# PRODUCT SAFETY BULLETIN 36474 MINECRUISER PARK BRAKE VALVE IMPROVEMENT – ADDENDUM TO BULLETIN 36395

Date: 7/05/2025

Issue: B

**Applicable** MineCruiser Mk6,Mk7 & Mk8 machines:

Park Brake Valve HY00433 /7-075577-700 improvement detailing updated detent and improved seal arrangement.

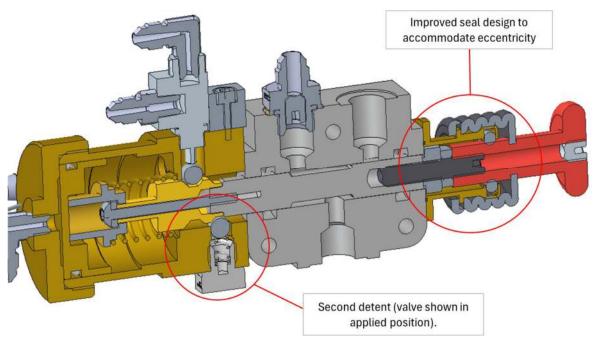
The proprietary park brake valve has been re-engineered to incorporate a detent in the released position when the valve is pulled up. This change results in a higher force being required to apply and release the valve but still complies with the force requirements from the Technical Reference Guide for Braking Systems used in Underground Transport.

Other issues had been previously identified with the valve sometimes malfunctioning due to contamination. As part of the revision, an improved sealing arrangement was also developed to reducing the likelihood of water or contaminants entering the valve spool through the valve boot / shaft interface.
